Test lead set, 'Voltage Test Lead, 3-phase + N', included with Fluke 173x, 174x Power Quality Loggers and 3540FC Power Monitor

CRITICAL SAFETY ALERT – PLEASE READ!

June 2018

174X Series Incorrect 3-Phase Test Lead Connection

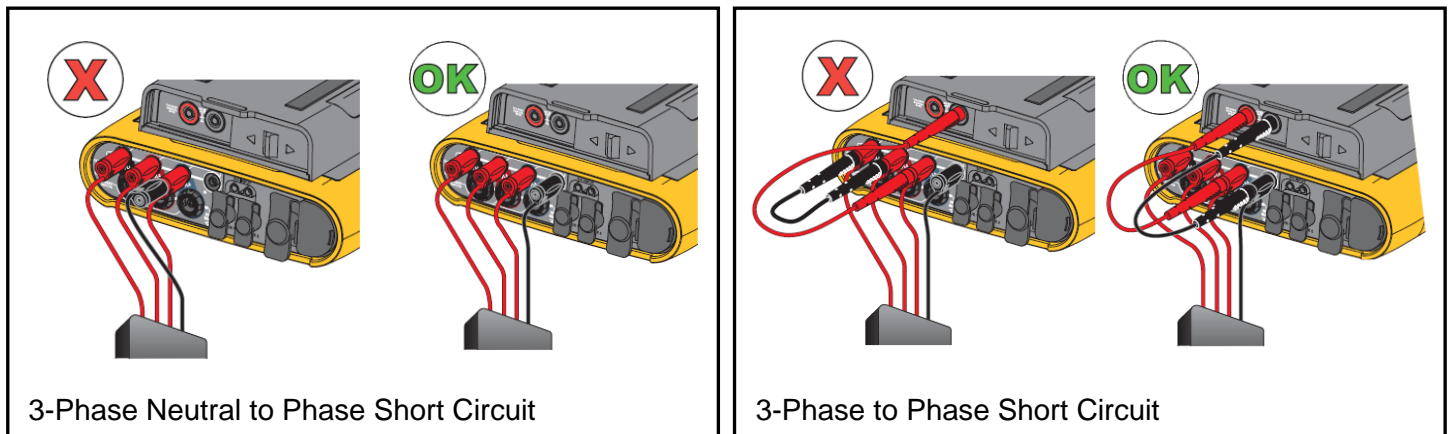
While these test leads are compliant with applicable safety standards, it is possible for a user to miswire the voltage connections on the test lead set when making connections to a Logger. See the diagrams below for examples of miswiring errors.

While the possible wiring errors shown below may seem obvious to trained personnel, if this miswiring were to occur, a phase-to-phase or phase-to-neutral short circuit could result, potentially **causing an arc explosion and posing the risk of serious personal injury or death.**

Examples of possible miswired voltage connections resulting in a short circuit (VOLTAGE CONNECTION ERRORS ARE INDICATED BELOW WITH A RED 'X');

Fluke urges you to discontinue use of the 'Voltage Test Lead, 3-phase + N' cable set and contact Fluke for a free replacement test lead kit. This replacement test lead kit incorporates straight banana connectors rather than stackable connectors.

Replacement test lead set installed.

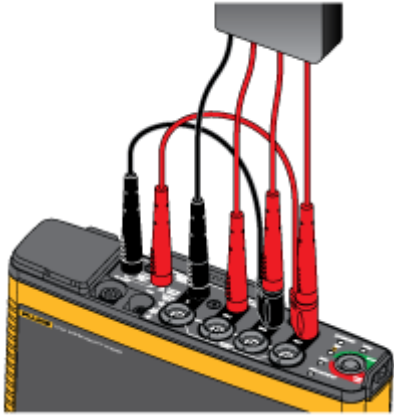
To facilitate powering the Logger from the measurement terminals, the replacement test lead kit additionally includes short jumper accessories with both a stackable connector and a straight banana connector. **The configuration of this replacement test lead kit eliminates the possibility of miswiring the terminals.** See below.
